# Application to Amend Alcoa Drilling and Operating Permit No. POS D&O 0148

Presented by:  
Steven Young

July 27, 2021

# Locations for Proposed Well in 2012 and 2021 Permit Applications

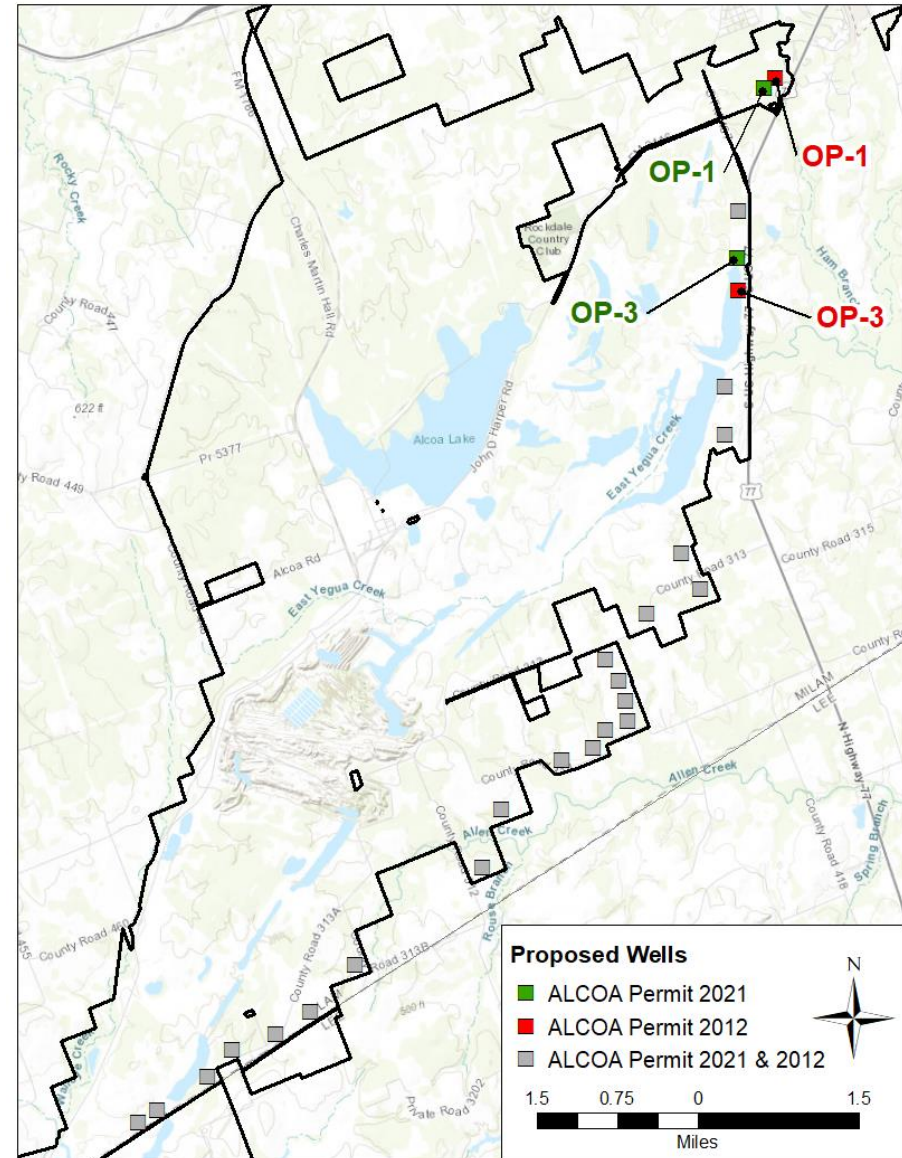
- Difference in OP-1 locations is 737 ft
- Difference in OP-3 locations is 1,567 ft
- Difference in remaining 22 locations is < 25 feet

# Results from Video Log from 10 Wells

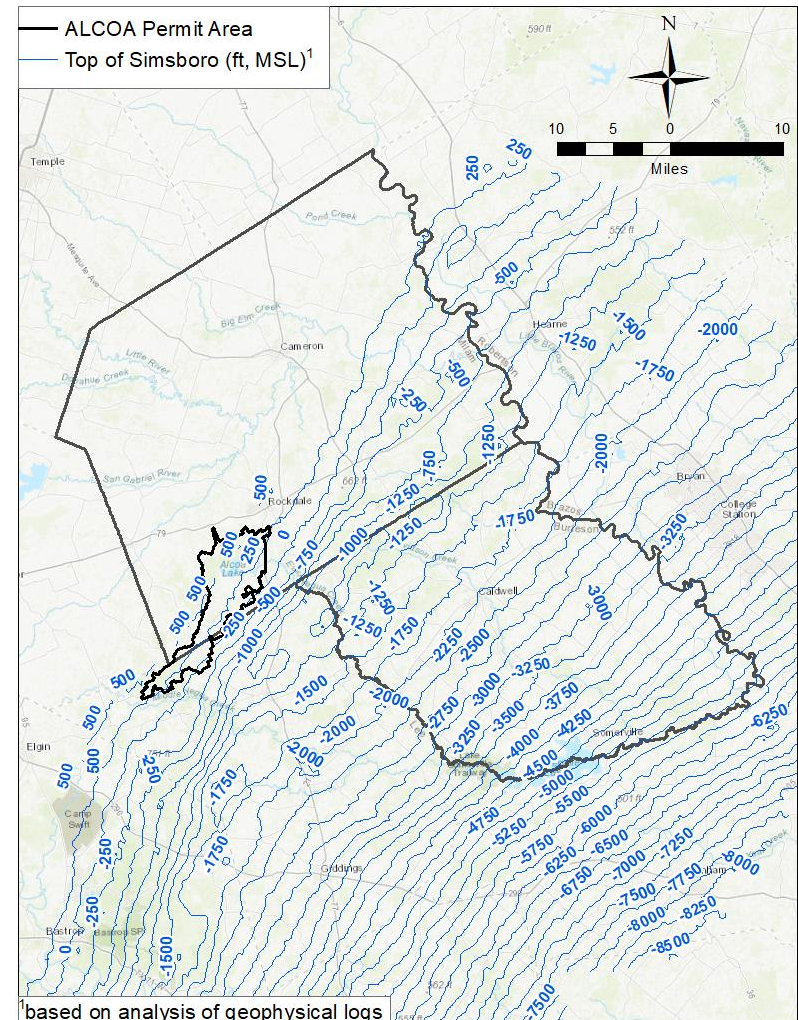
\*the screen interval averaged 134 ft for the 8 wells

- 3 of 7 wells have 10 ft of less difference between construction sheet and video log
- 3 of 7 wells have between 25 and 40 ft of difference between construction sheet and video log

# Aquifer Assignment to Wells (con't)

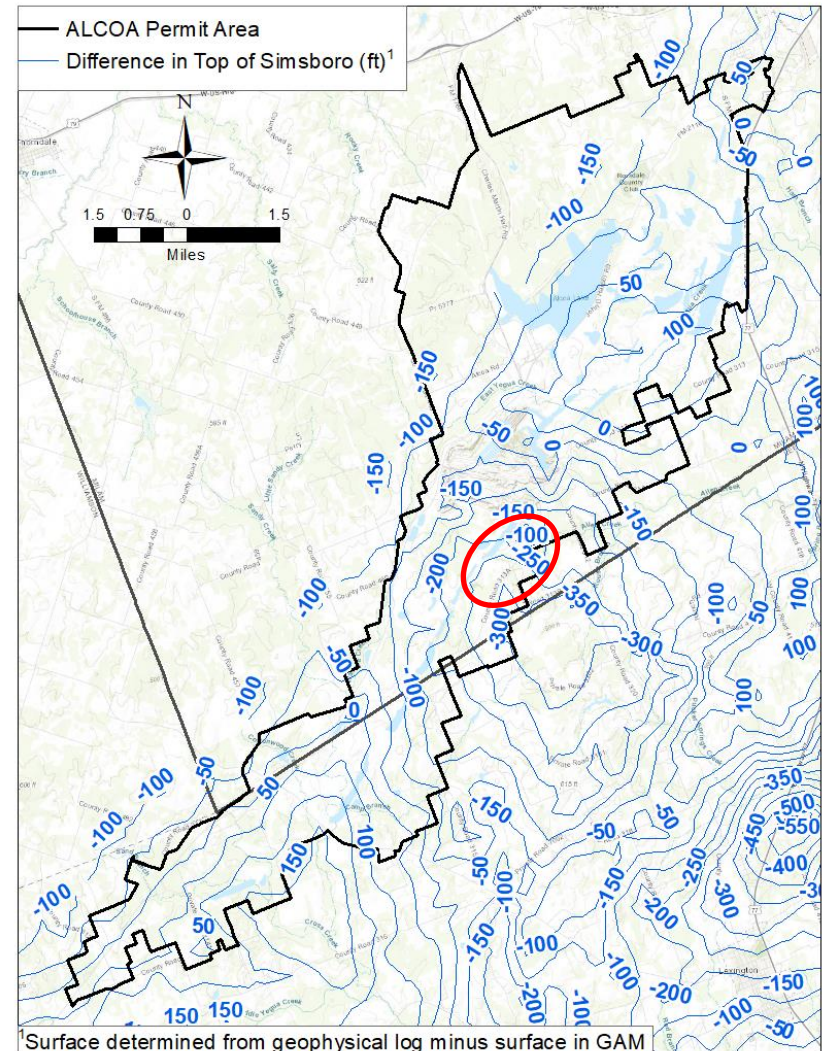
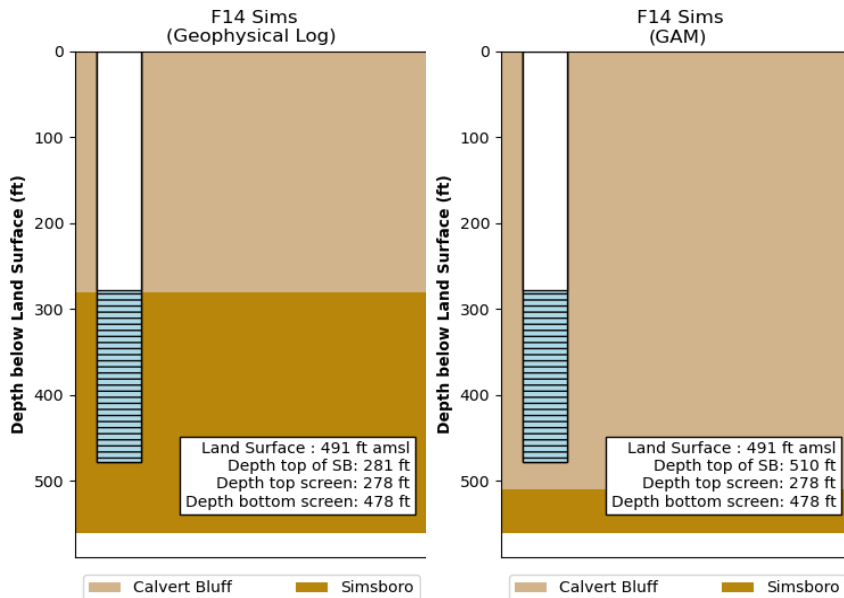
- INTERA Classified 55 out of the 56 wells as Simsboro wells
  - classification based on geophysical logs
  - difference between top of Simsboro based on geophysical log and GAM is at right
  - 11 of the 32 existing wells mapped into the Calvert Bluff based on GAM data (see below)
  - 11 wells are located mainly in red circle
  - Well F2-Sims classification as Simsboro is uncertain

# Geophysical Log for Well AX 10-5

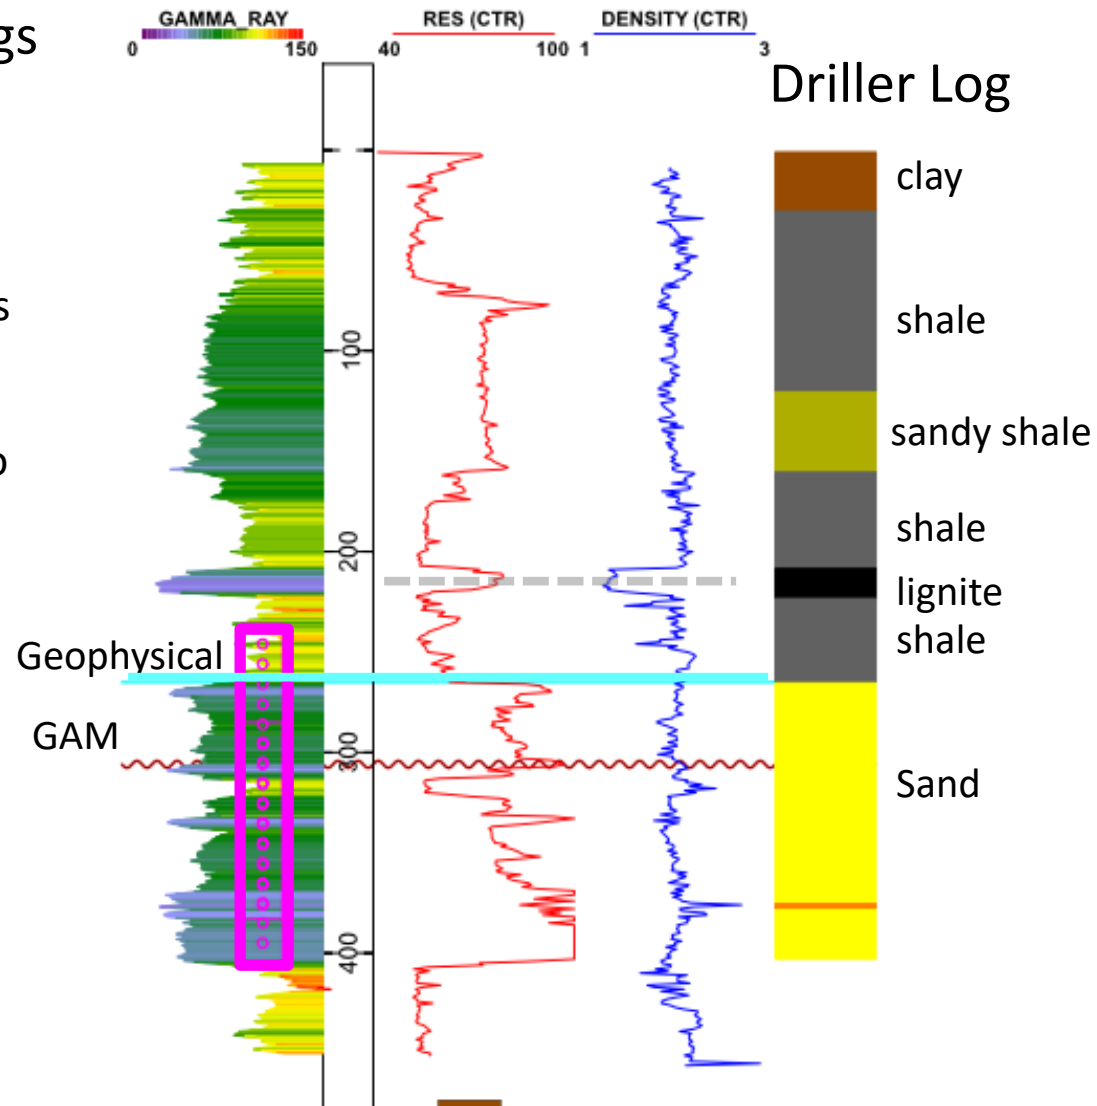
- Top of thick sand agrees with kicks in the resistivity and gamma ray and top of Simsboro (geophysical)
- Lignite layer agrees with kicks in gamma ray, resistivity, and density
- Majority of the screen is in the Simsboro formation
- Main coal layer is in the Calvert Bluff

# Well Spacing – Property Boundary

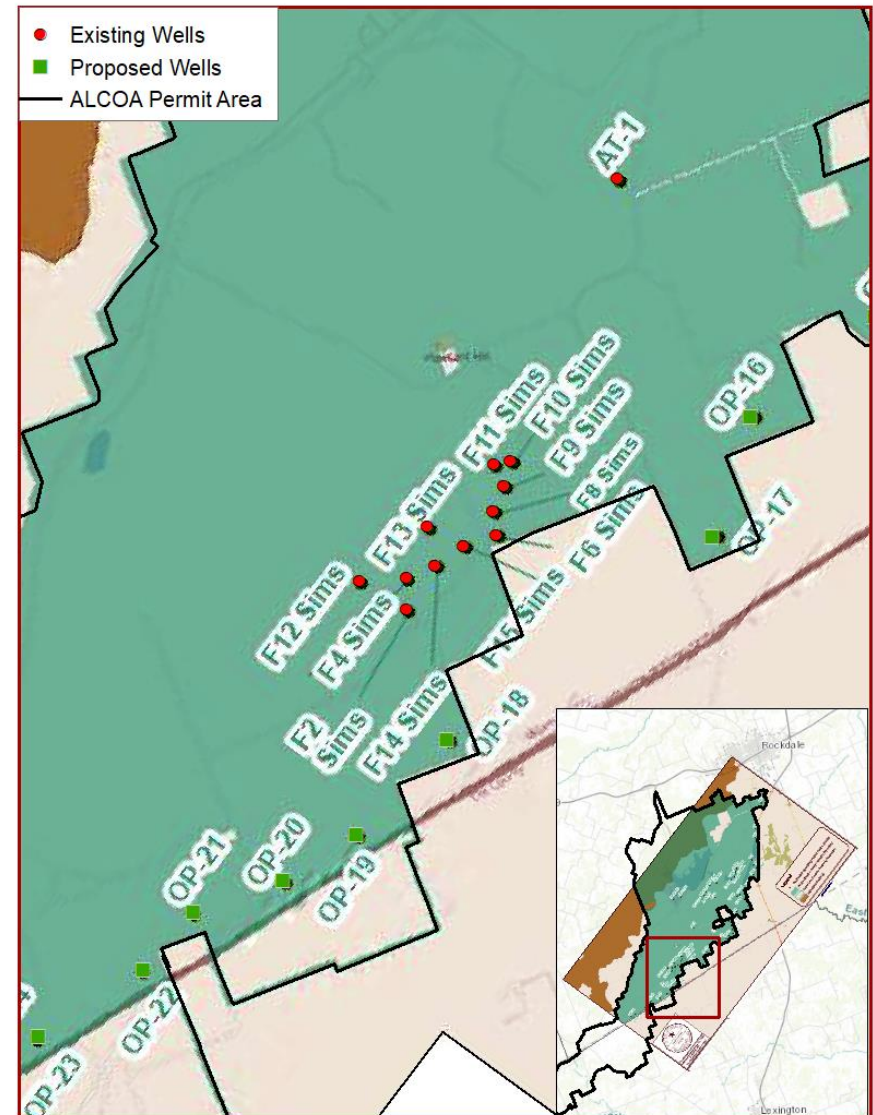
Confirmed that well spacing rules were met for property boundary

- 8 wells where Table 1-3 calculated distances are more than 200 ft greater than INTERA distances
- 3 wells where Table 1-3 calculated distances are more than 500 ft greater than INTERA distances

# Calculated Average Drawdown From December 2010

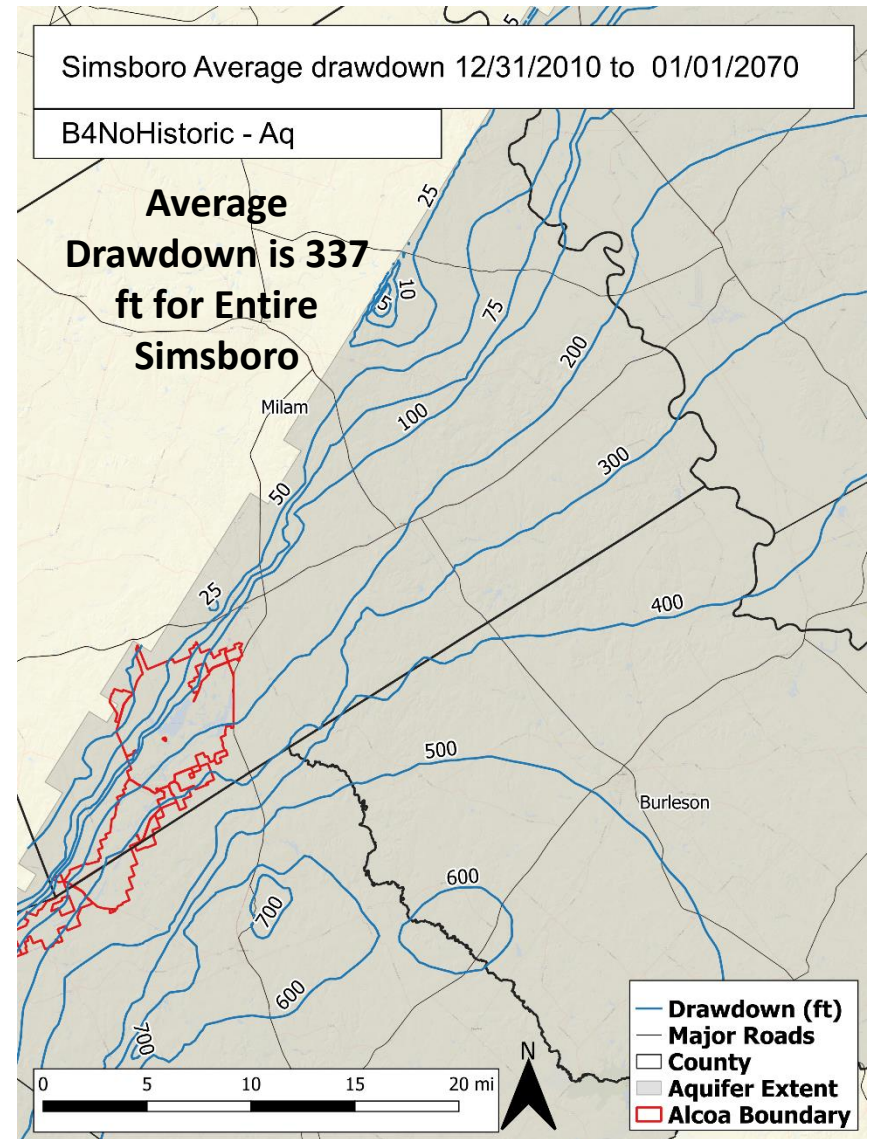
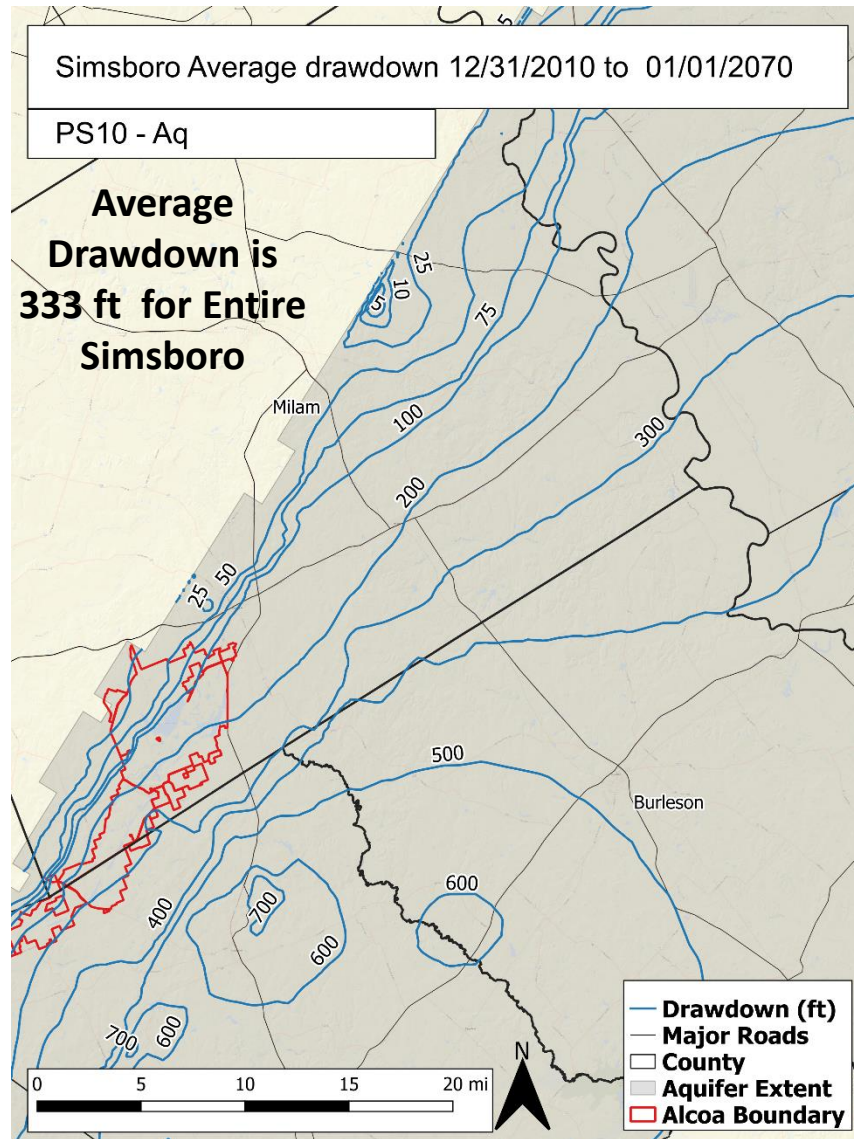
\*ALCOA calculates are ~15 ft above INTERA's values
